VILLAGE OF ORLAND PARK

Meeting Agenda

[2020-0319](#) Orland Fire Protection District Maintenance Building - Development Petition for Site Plan, Elevations, Landscape Plan, Variances

File Number: **2020-0319**
 Orig. Department: **Development Services Department**
 File Name: **Orland Fire Protection District Maintenance Building - Development Petition for Site Plan, Elevations, Landscape Plan, Variances**

PRELIMINARY SITE PLAN

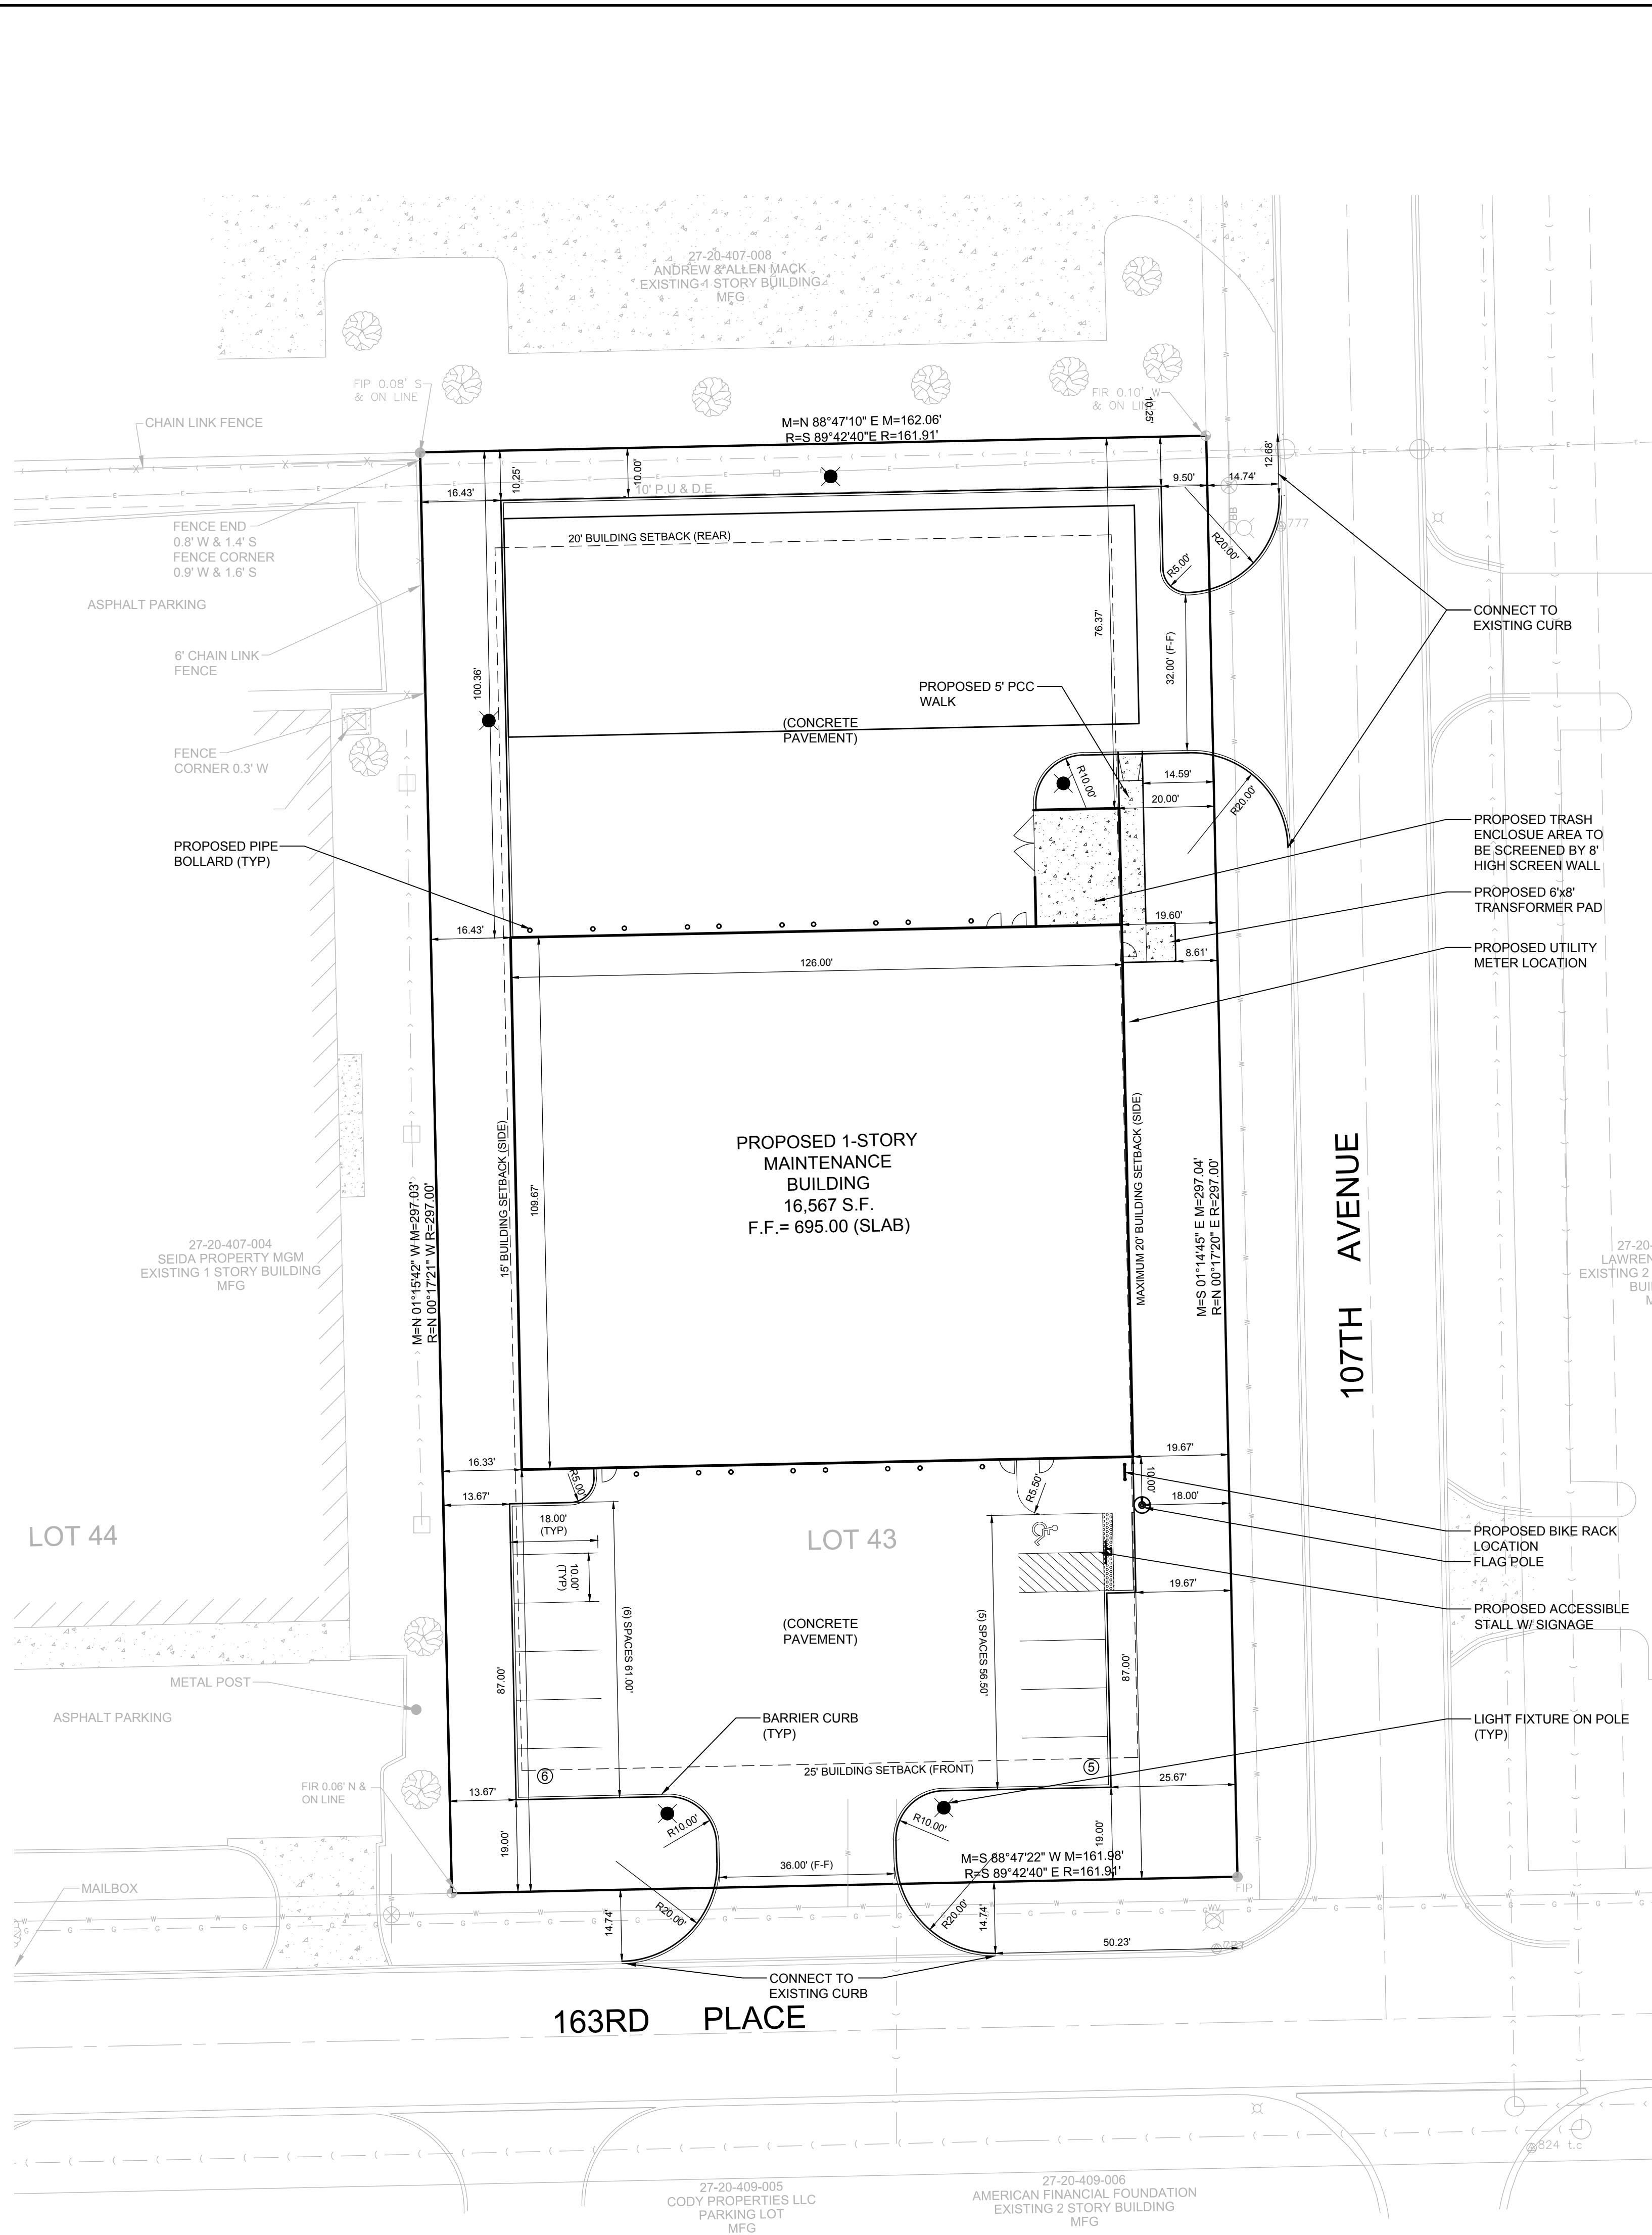
The proposed site plan consists of a 16,567 square foot building, a parking lot with eleven (11) parking spaces located to the south of the building, a concrete pavement area located to the north of the building, and new landscaped areas. The main entrance to the building and a total of four (4) vehicle bays will be located on the south elevation facing 163rd Place. On the north elevation, a total of five (5) vehicle bays with overhead doors are proposed, one of which will be used as a wash bay. The proposed dumpster enclosure will be attached to the building and is proposed on the north (rear) elevation.

Garbage Enclosure - A garbage enclosure is proposed on the north (rear) side of the building side of the building. As shown on the site plan and building elevations, the enclosure will be attached to the building, constructed of eight (8) foot tall brick walls that will match the brick used on the building and will be constructed of eight (8) foot tall walls in precast concrete matching the building. The gates will be constructed of opaque metal panels that will be painted Safety Red to match the access doors and overhead garage doors on the adjacent elevations. As proposed, the garbage enclosure meets the requirements of the Land Development Code.

I move to recommend to the Village Board approval of the **Preliminary Site Plan** titled "Preliminary Site Plan", prepared by Knight E/A, Inc., Sheet C-1.0, dated and last revised July 10, 2020, subject to the following conditions:

4. The photometric plan shall comply with all lighting requirements per Section 6-315.
5. The proposed use (Motor Vehicle Services) shall meet Village Code requirements, including Title 6 Chapter 2 Nuisances and Title 6 Chapter 4 Noise Control, and the conditions listed in Section 2-102 of the Land Development Code.

6. The required detention pond stormwater volume shall be provided off-site on the property identified as PIN 27-20-207-007-0000 and owned by the Orland Fire Protection District. Alternatively, if stormwater detention cannot be provided off-site, the plans shall be revised to provide the required stormwater detention on-site. Any substantial changes to the approved plans shall be brought back for consideration to the Plan Commission and Board of Trustees, in accordance with Section 5-101.
